**100-NR-1 Operable Unit Treatment, Storage, and Disposal
Interim Action Record of Decision**

**100-NR-1/100-NR-2 Operable Unit Interim Action Record of
Decision**

**Hanford Site – 100 Area (100-N)
Benton County, Washington**

**Explanation of Significant Difference
May 2003**

Figure 2. 116-N-1 Conceptual Subsurface Cross Section.

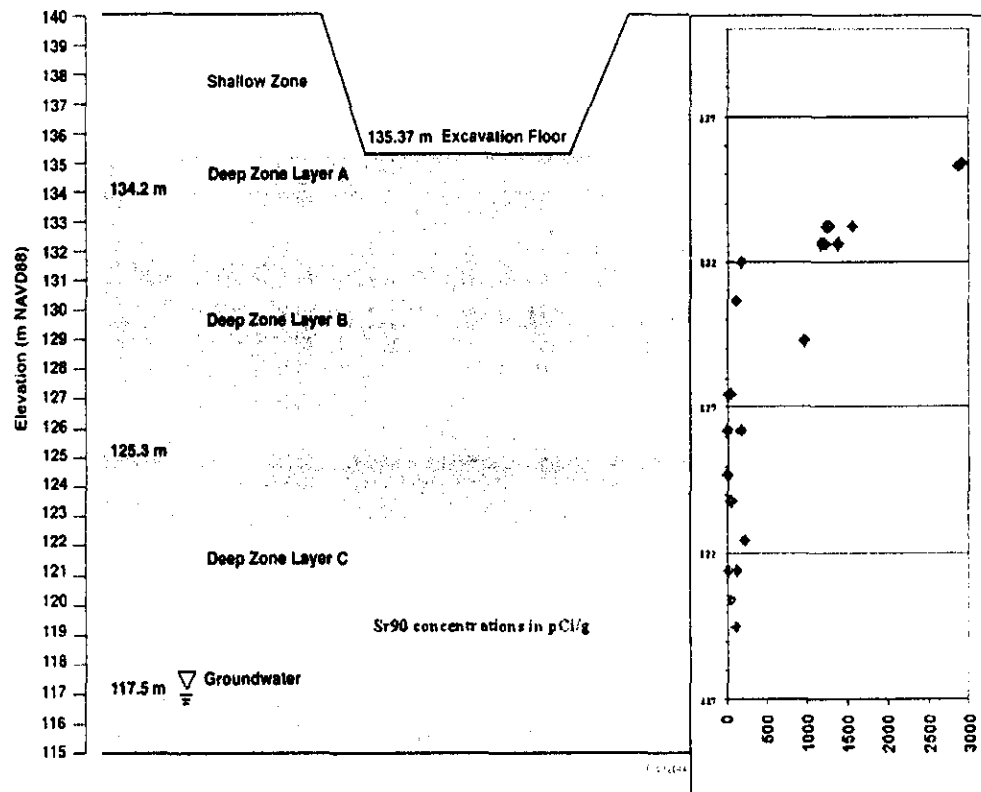
Figure 2 shows a conceptual model of the 116-N-1 waste site. Based on the application of RESRAD, the waste site is divided into three separate layers for modeling to demonstrate compliance with the RAOs. "Layer A" averages approximately 1,802 pCi/g of strontium-90. "Layer B" averages approximately 791 pCi/g of strontium-90, while concentrations in "Layer C" average approximately 78 pCi/g of strontium-90. The average strontium-90 concentration in the excavation area above Layer A is 2,597 pCi/g, which will be removed and disposed. The RESRAD modeling results show that soil contamination only in Layer C (Figure 2) would cause strontium-90 to exceed the MCL for protection of the groundwater. The MCL for strontium-90 in the groundwater is 8 pCi/L, and the RESRAD model calculates a discharge concentration of strontium-90 to the groundwater interface of 37.5 pCi/L. Based on these results, excavation would need to continue an additional 20 m (65 ft) to the groundwater table to remove Layer C. No additional radionuclides or chemicals remaining in Layer A, Layer B, or Layer C would exceed the standards for protection of groundwater.

The RESRAD modeling indicated that the lowest soil column layer beneath the 116-N-1 waste site (Layer C, Figure 2) contributes 37.5 pCi/L of strontium-90 to the groundwater, which exceeds the 8 pCi/L MCL for strontium-90 if 76 cm (30 in.) of irrigation per year is presumed. However, applying the RESRAD model without presuming irrigation shows strontium-90 levels leaching to the groundwater of 5.5 pCi/L, which meets the MCL of 8 pCi/L for strontium-90.

1. Add to the selected remedy, "DOE shall prohibit irrigation at the 116-N-1 waste site and eliminate irrigation from modeling at 116-N-1, based on the approved ESD, which identifies additional excavation greater than 4.6 m (15 ft) is not required."

Table A-1. Assumption Summary: Excavation to Groundwater (Conventional).^a

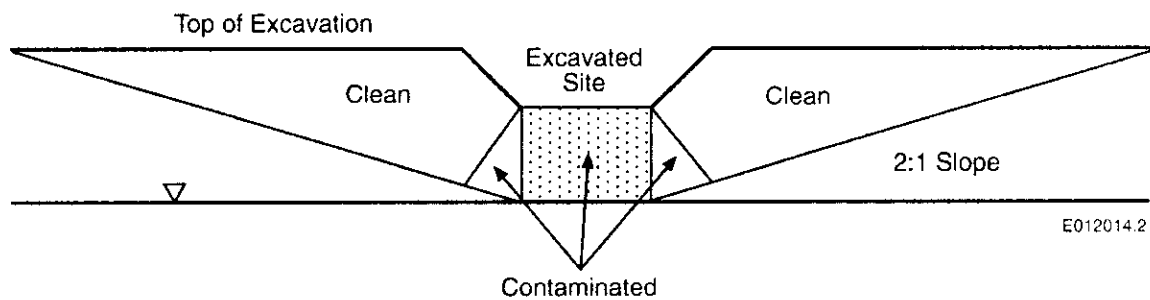
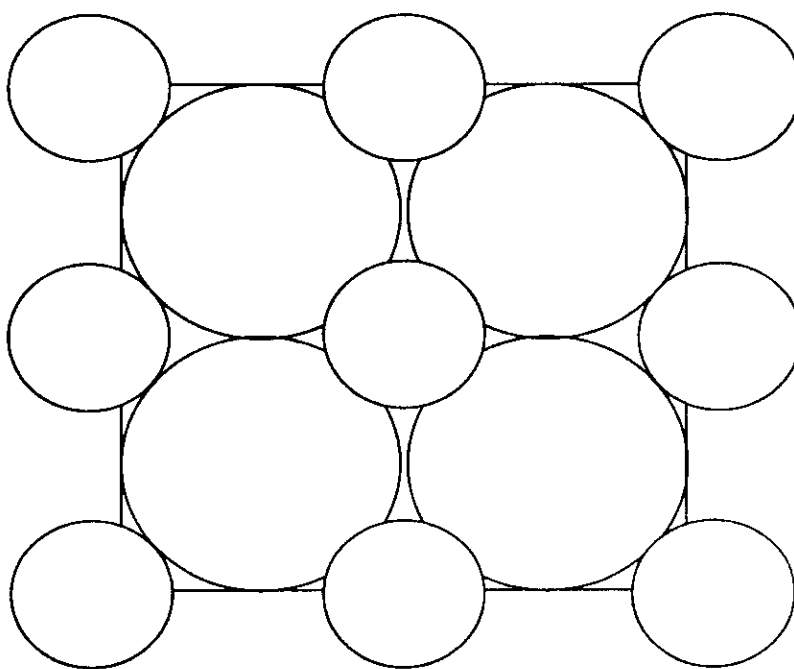
Item	Assumption
Excavate and stockpile clean overburden, then return to excavation	Assumes 2:1 slope.
Excavate and stage for transport contaminated soil	Assumes that entire footprint and additional 30% of soil beyond excavation footprint is contaminated.
Transport and disposal of contaminated soil in the ERDF	Assumes 458,562 additional tons transported and disposed and construction of ERDF capacity.
Backfill from onsite borrow pit	Assumes borrow pit less than 6 km from waste site.
Project support	Includes radiation control technician, health and safety, field oversight, engineering and environmental, waste management, and sampling and analytical costs for the 32-month duration.

^a Assumes traditional excavation methods currently used. Generalized conceptual excavation cross section shown below.

Table A-2. Assumption Summary: Soil Removal by Augering to Groundwater.^a

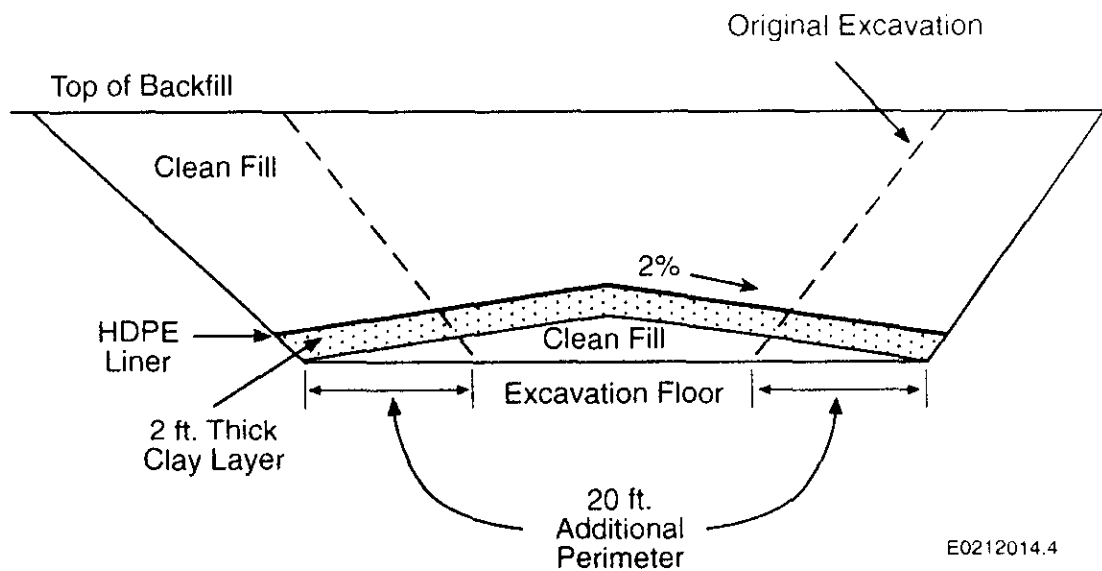
Item	Assumption
Augering	Assumes 2-m-diameter holes with 1-m-diameter holes in between. This equates to approximately 2,283 holes (2 m each), and 2,553 holes (1 m each) over the entire excavation footprint.
Grouting	Grout displaces soil in the holes. Assumes a batch plant is set up onsite.
Transport and disposal of contaminated soil in the ERDF	Assumes 349,007 additional tons transported and disposed and construction of ERDF capacity.
Project support	Includes radiation control technician, health and safety, field oversight, engineering and environmental, waste management, and sampling and analytical costs for the 62-month duration.

^a Four large bore (2-m) machines used in this estimate. Only 98% of the contaminated soil will be removed due to the circular nature of holes. Basic layout pattern is shown below.
